**ADDENDUM NO. 7****DATE:** April 28, 2022**CONTRACT NO.:** HU-0029-B01**PROJECT:** UNION CITY - NEW GRADE 7 THROUGH 9 SCHOOL

DESCRIPTION: **Union City - New Grade 7 through 9 School**
 Union City, NJ
 Addendum No. 7

BUILDING SECTIONS

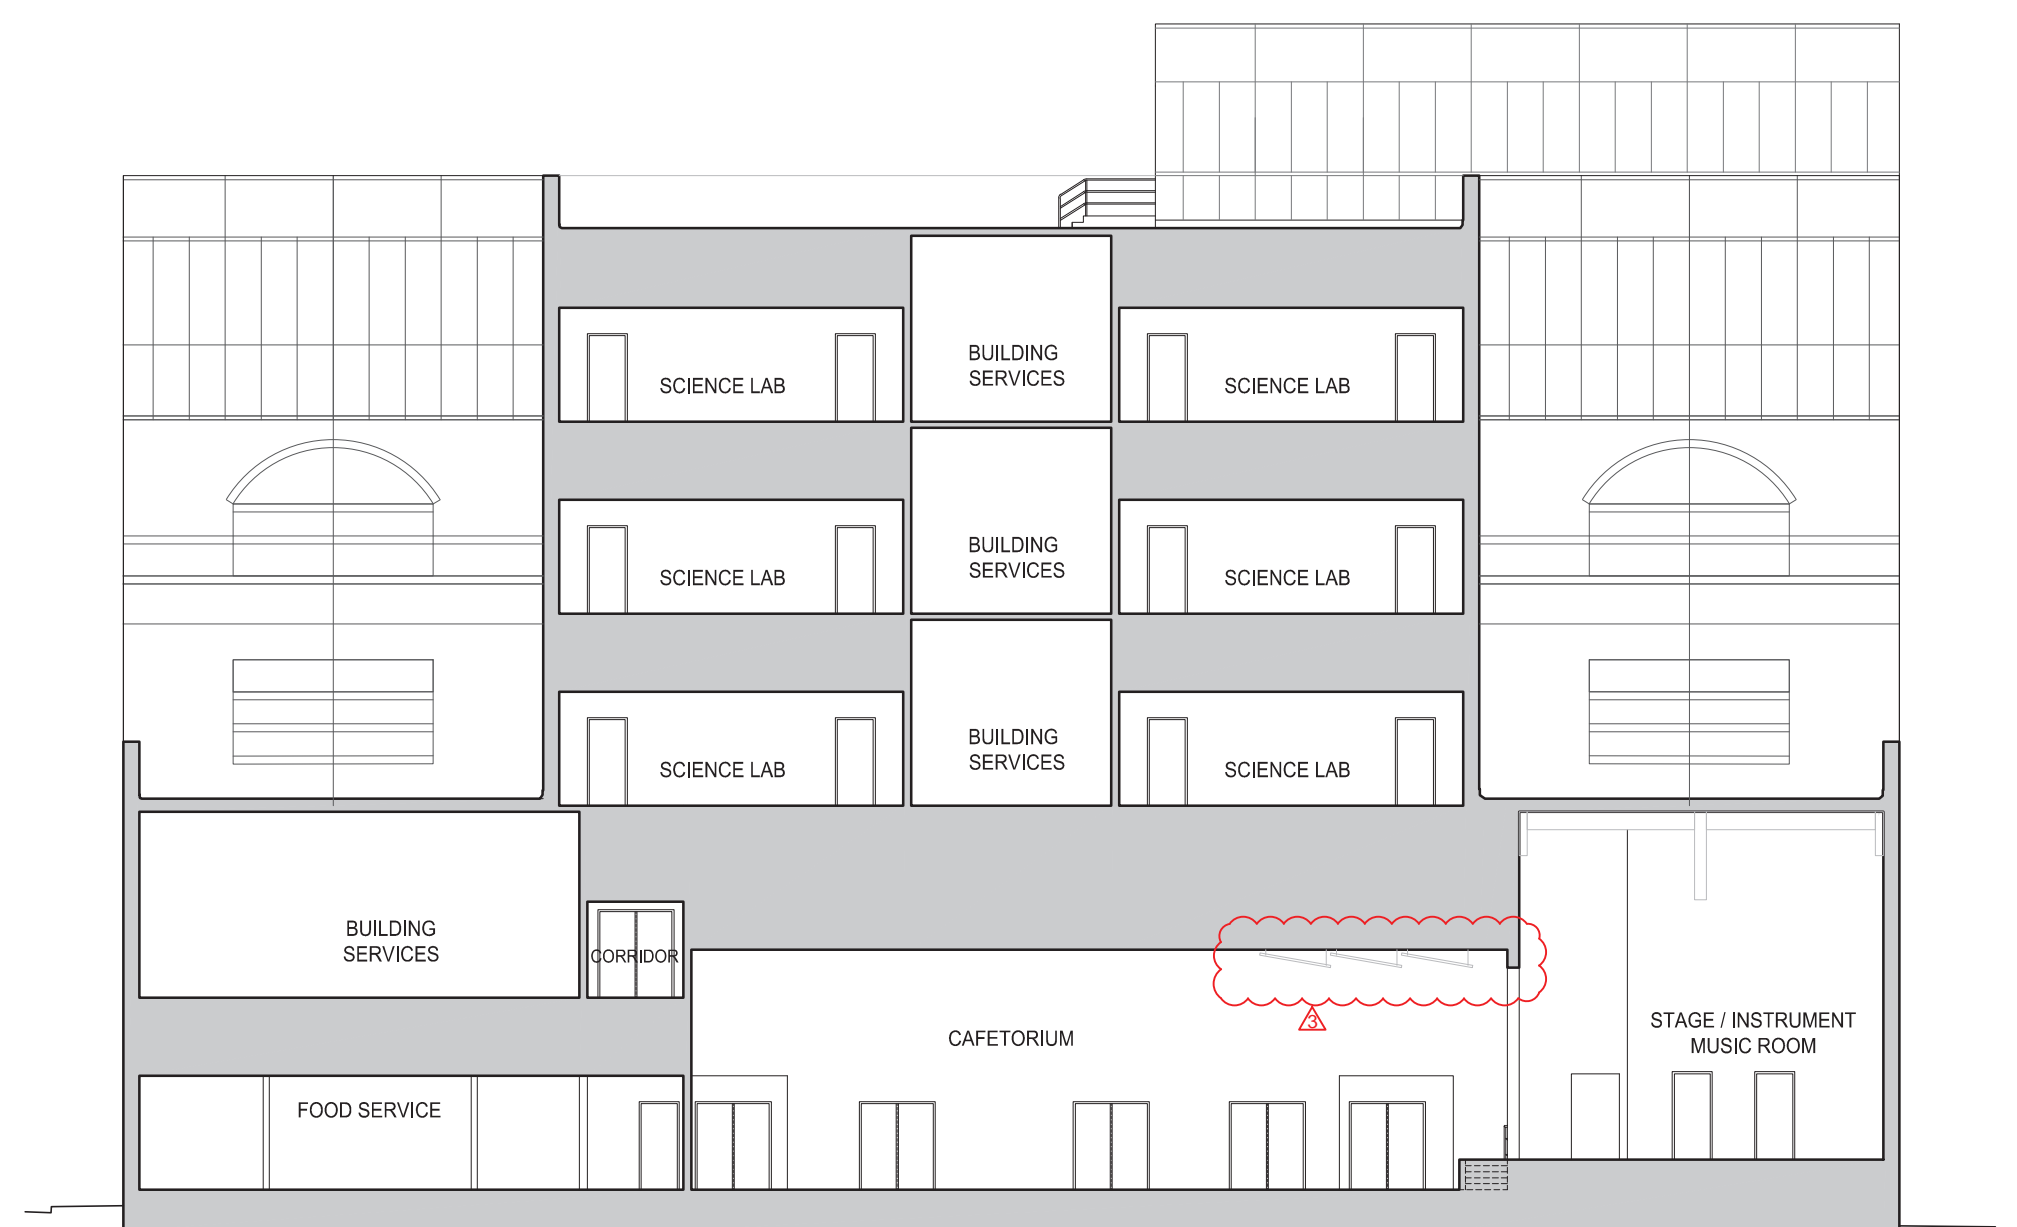
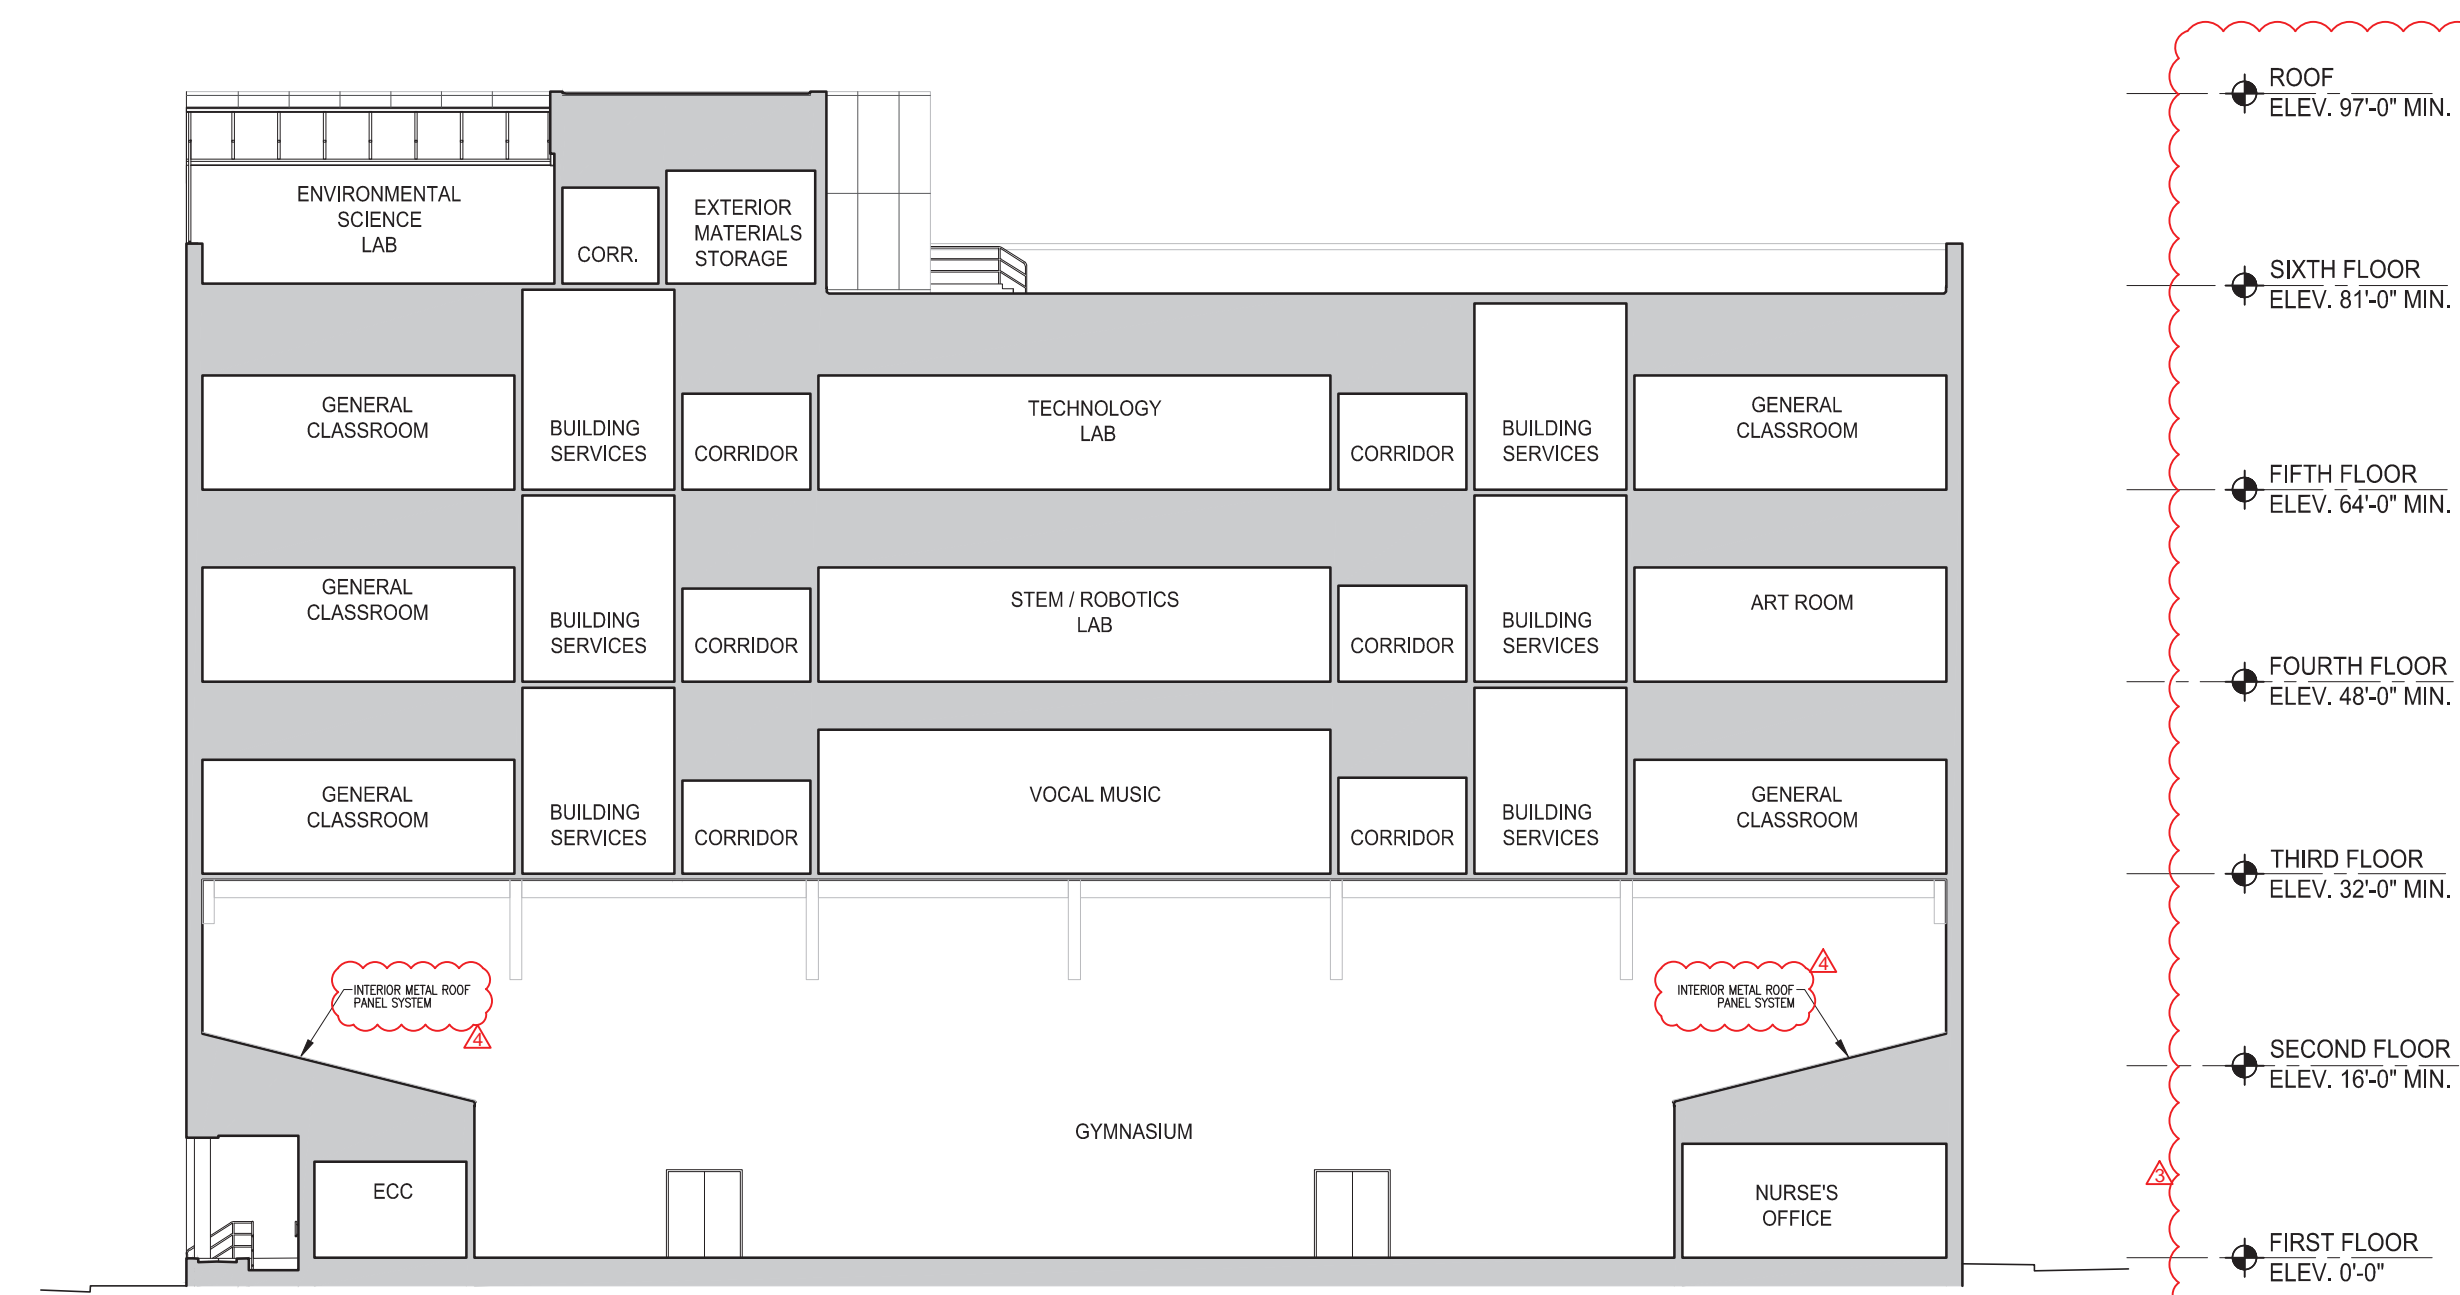
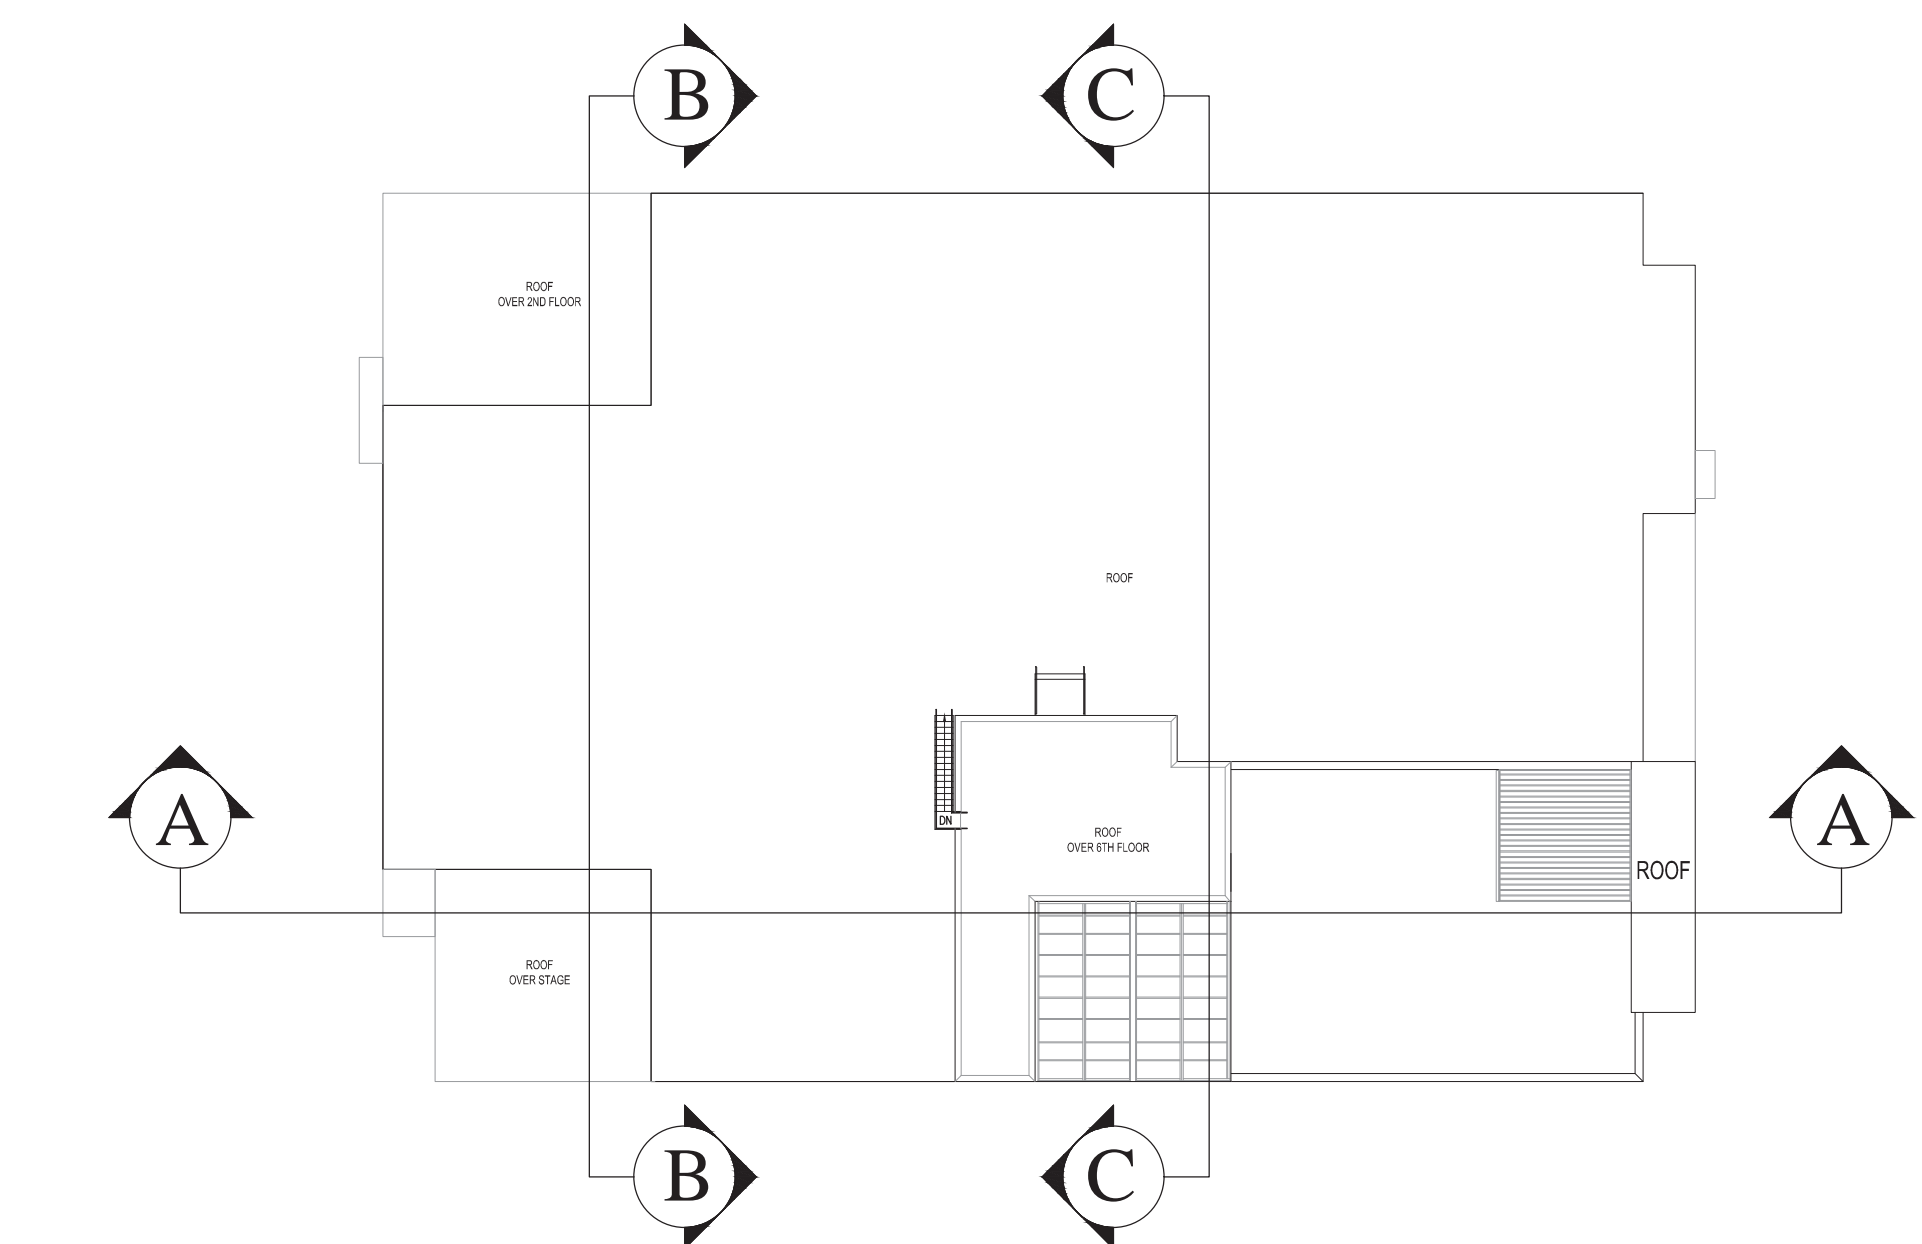
2. **QUESTION:** At either end of the gymnasium, the sloped cap on top of the one-story functional gymnasium space, please confirm the intended

material capping the sloped area. Has SDA considered provisions for keeping this area/surface clean? (BQ 385)

c. **ADD:** Section C1000.00 – Interior Construction, add paragraph I.B.5.**b.**, as follows:

b. Sloped Surfaces in Gymnasium.

(1) **Structural performance.**

(a) Uniform load: 20#/sf minimum.

(b) Concentrated load: 300# minimum over an area 30" x 30" maximum.

(c) Deflection: l/180 maximum.

(2) **Configuration.**

(a) Slope surface 4:12 maximum.

RESPONSE: The sloped surfaces at approximately the second floor elevation and job-North and South ends of room A-110 Gymnasium shall be finished with an interior metal roof panel system. The surface is not intended for human occupancy or storage. The District is responsible for fall protection when access for maintenance is required. See the revised drawings A-101 First Floor and Second Floor Plans and A-301 Building Sections, attached and performance specification C1000.00 Interior Construction. Refer to item B.2.c. in this Addendum.
